Access Compliance Report Public Rights-of-Way (Curb Ramps)

Main Street: CRAWFORD_CANYON_RD Cross Street: BARRETT_LN Location: NE

ADA ID: RPRK211007180451 Ramp Type: Type 4 - Parallel Initial Pass/Fail: Fail Overall Compliance: No Severity Score: 0

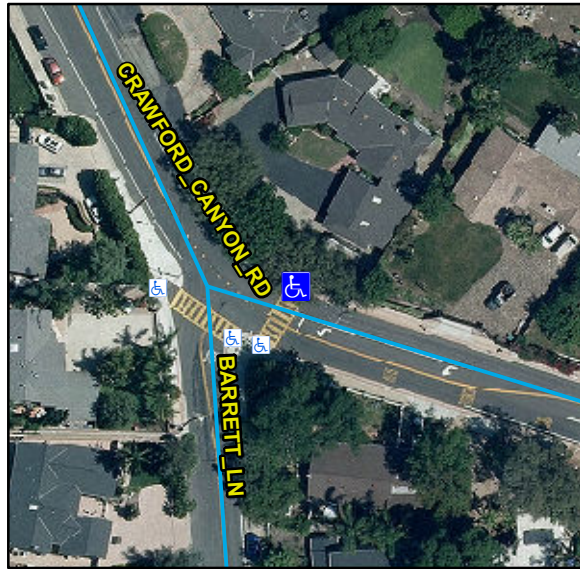
R304.2.2, STD 1115

Remove & Replace Entire Ramp.
